# Charlotte Historic District Commission Application for a Certificate of Appropriateness

ADDRESS OF PROPERTY 1330 Thomas Avenue, Plaza Midwood Local Historic District HDC 2011-043

SUMMARY OF REQUEST Front Porch Renovation

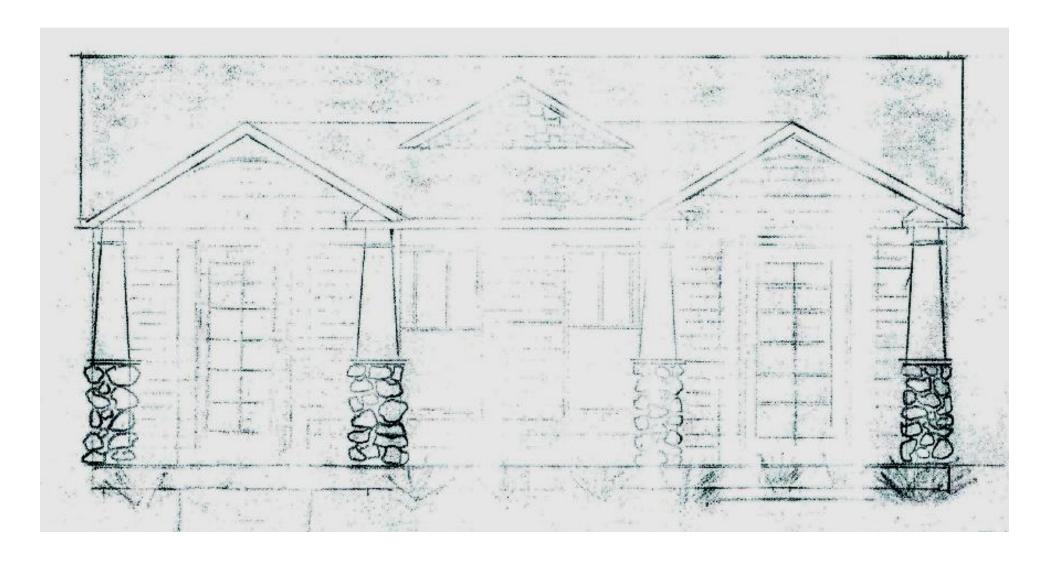
The plans submitted for this project are difficult to read, and it is unclear what the full intent of the project is.

One element of the proposed renovation of the twin porches is the covering of the brick column bases with stone facing. These elements are not typical square brick column bases. They have a tapered flare design, which may be lost if they are covered with stone facing.

It is hoped that the applicant can clarify the full intent of the project at the April HDC Hearing.
